RCA MFG. CO., INC.  
Ned. Ver. v. Historie v/d Radio

MODELS IAX, IAX2  
Ch. RC1003A  
MODELS IX, IX2  
Ch. RC-1003

**CHANGES, NOTES**

Circuit for "PM" and "EM" Speakers in 1X, 12X, and 14X Series.

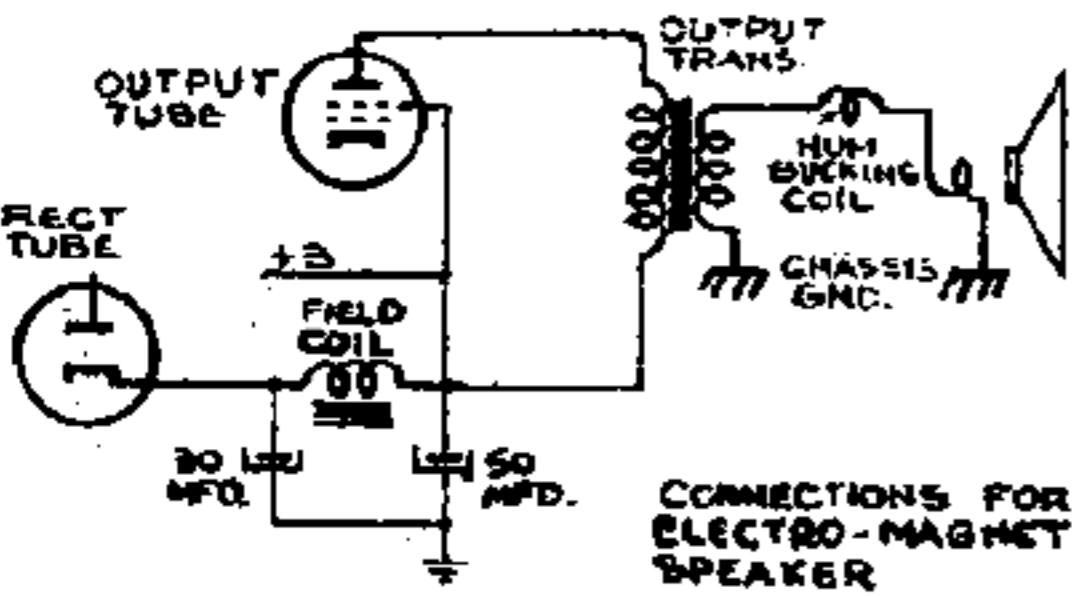
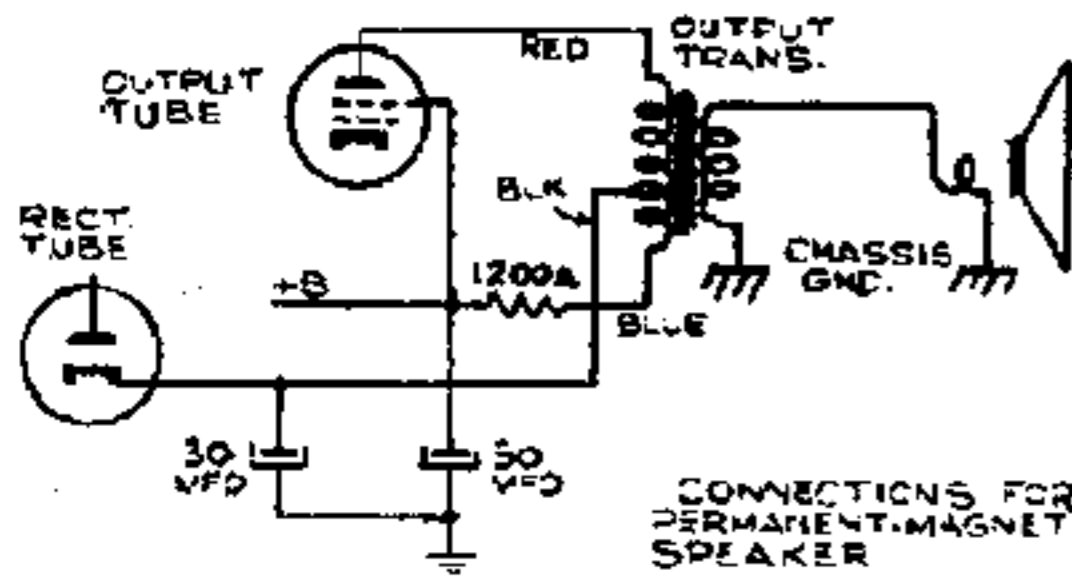
Speaker changed from "PM" to "EM":

First Production of the following models use RL-81-B2 "PM" (permanent-magnet) speaker. In 2nd Production, the speaker is changed to RL-86-A3 "EM" (electro-magnet) speaker. The circuit for each type of speaker is shown in the accompanying diagrams.

**CV-112X CONVERTER**

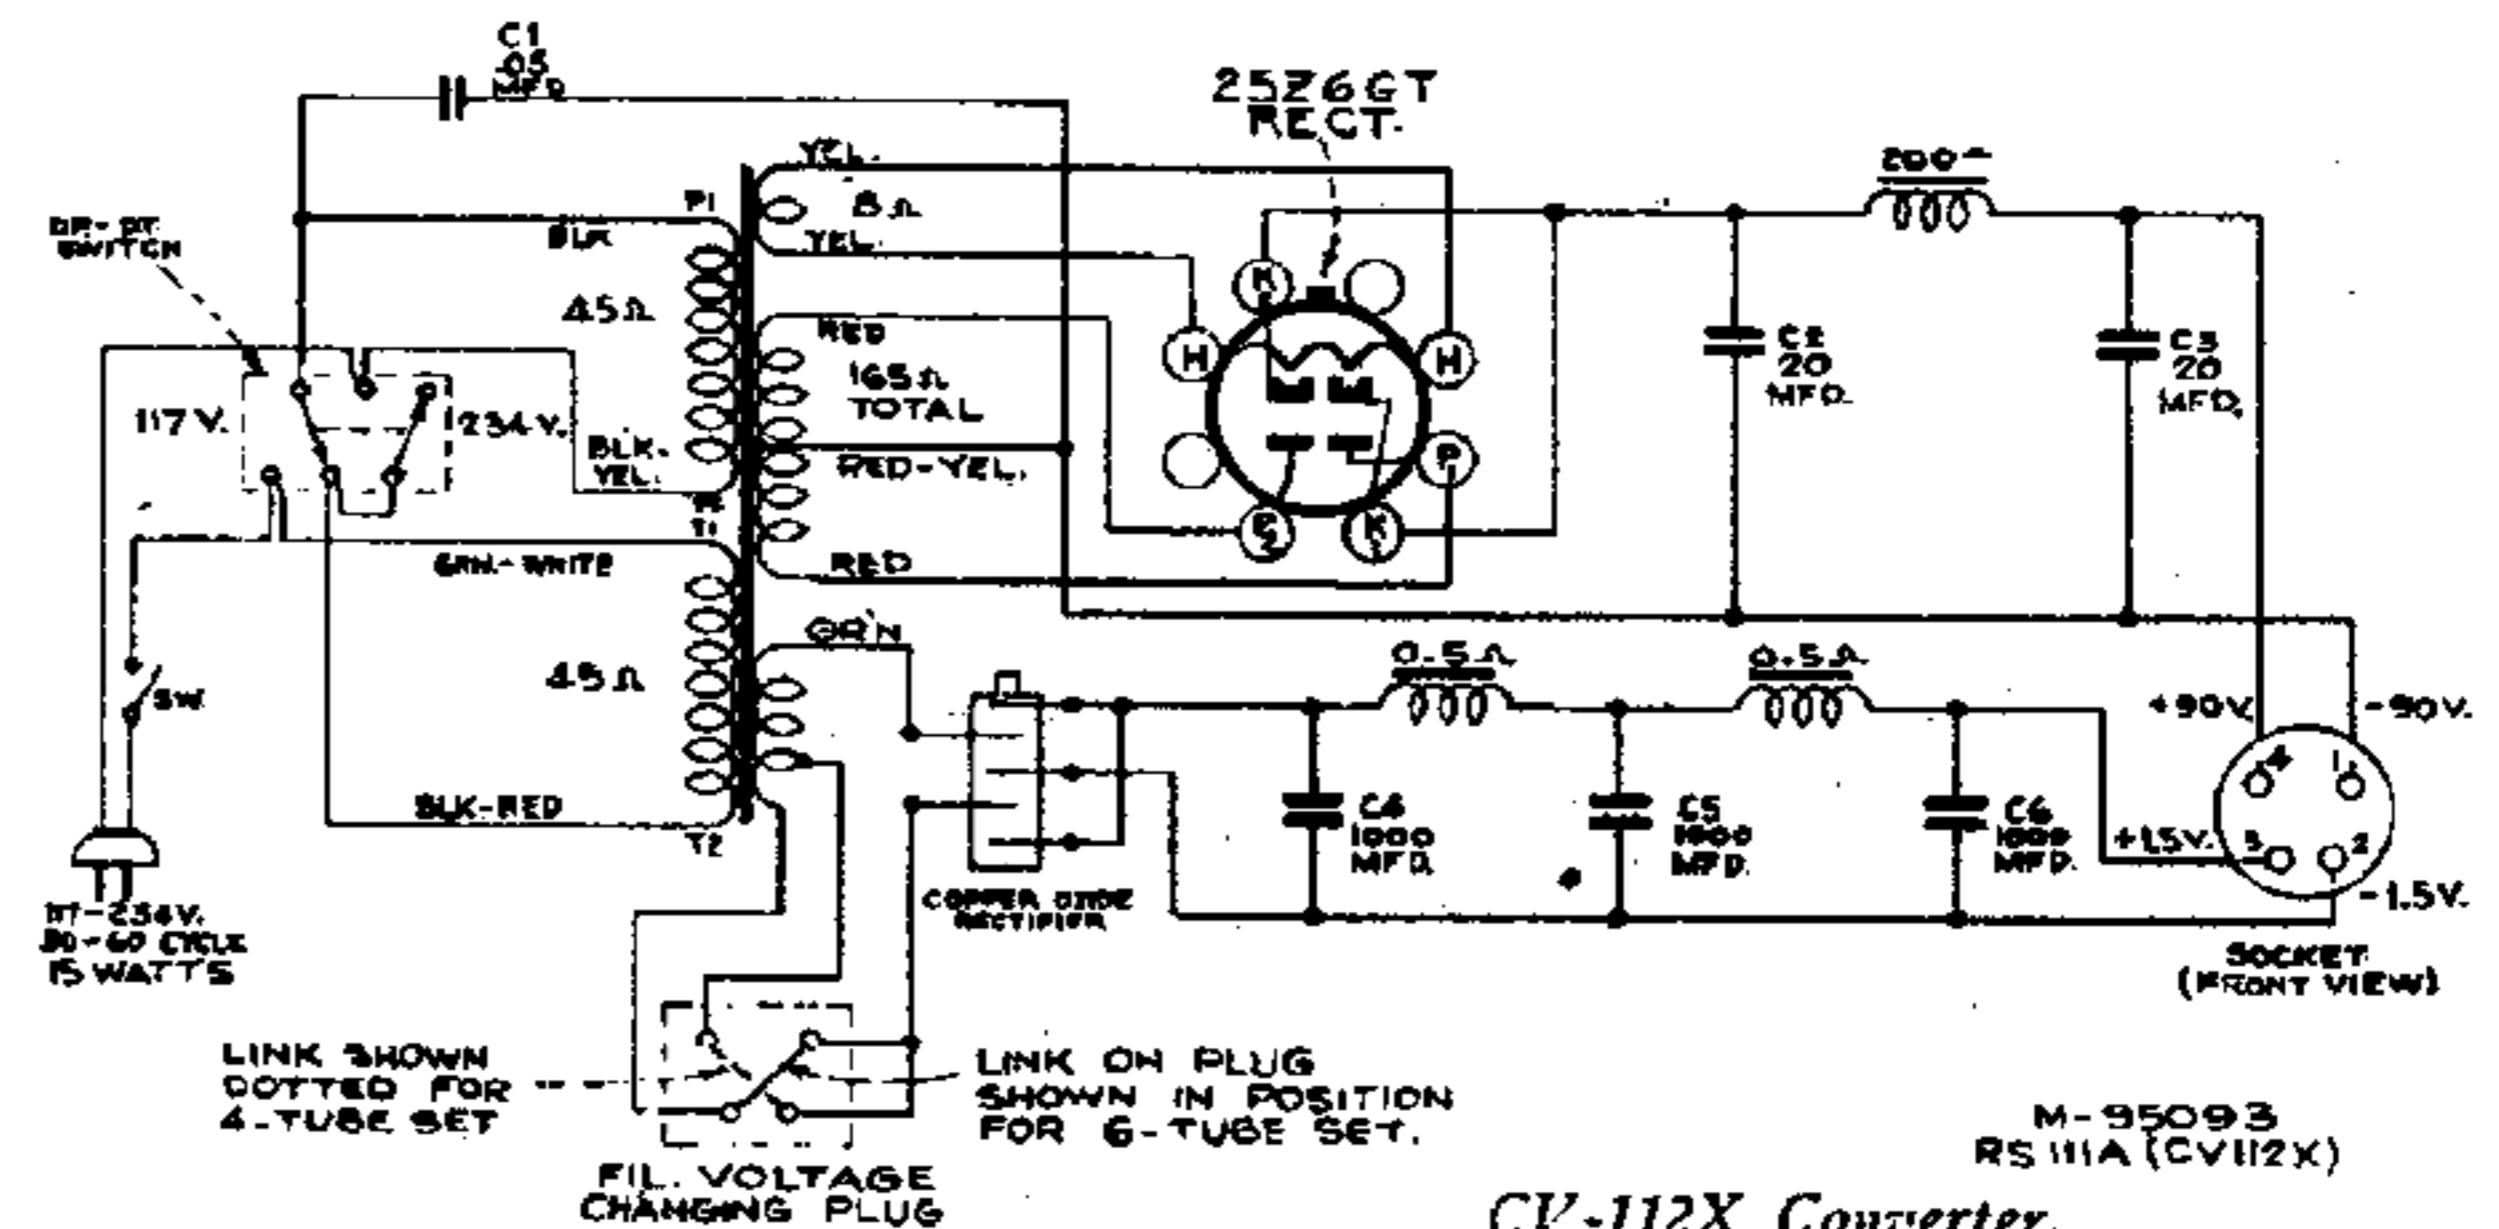
The CV-112X is designed to convert Models QB2, QB5, and QB6 from battery to a-c operation. It differs from the CV-112 in that it has a tapped filament winding to provide correct filament voltage with 4- and 5-tube, or 6-tube receivers. A plug, which fits in a socket on the side of the unit, is used to select the correct tap, as shown in accompanying diagram.

**SPEAKER GAUGE No. 39598**

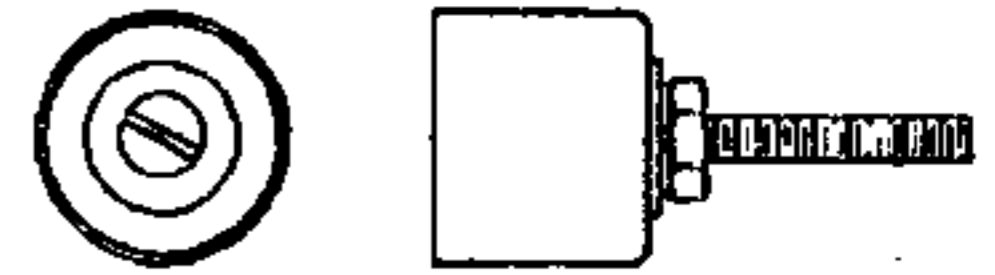
A special gauge, No. 39598, is now available for centering the voice coil in Model BP-10 with elliptical speaker.
